Notice of Allowability

10/689,393

PANEL ASSEMBLY FOR A MOTOR VEHICLE

Fig. 4

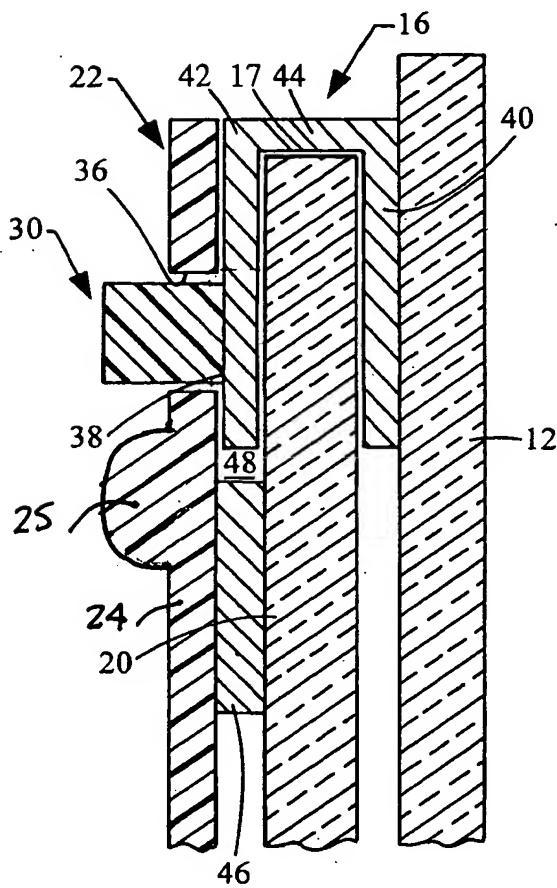
The proposed drawing changes dated 11/1/2005 are not approved by the Examiner. Attached are proposed drawing changes made by the Examiner and approved by the attorney of record. The following changes are shown in red: In Figures 4 and 6, element 25 has been added, and Figure 7 has been added.

Fig. 6

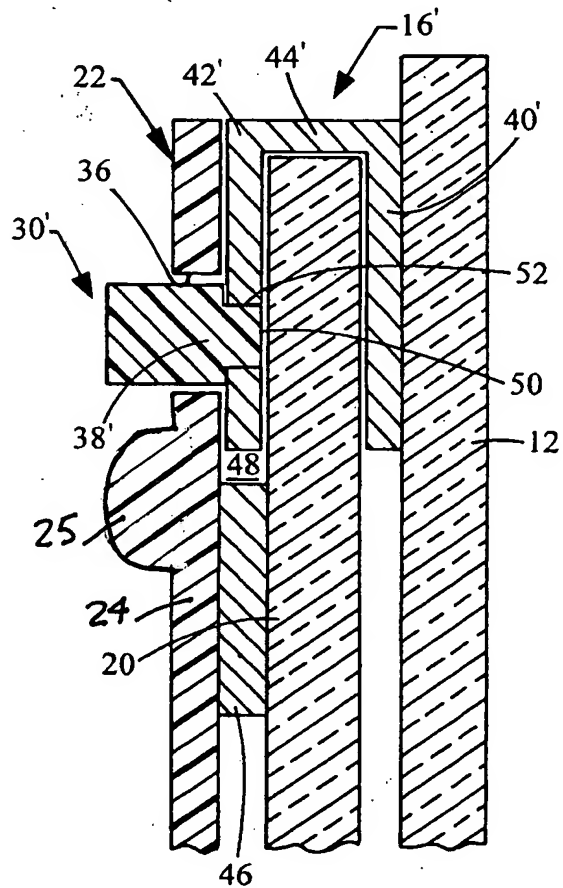
In paragraph [0027], line 4, "52 (FIG. 6)" has been deleted; and

Fig. 7

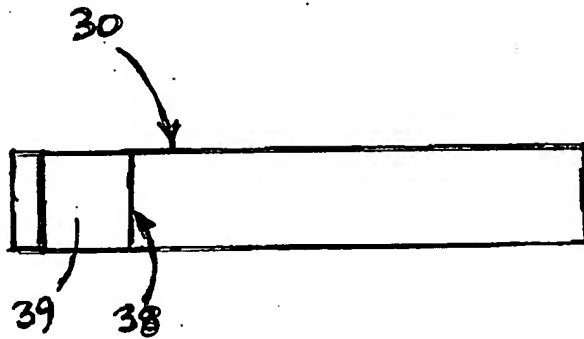
--FIG. 7 is a plane view of the cam depicted in Figs. 1-4.--

--(39, Fig. 7)-- has been inserted after "teeth".
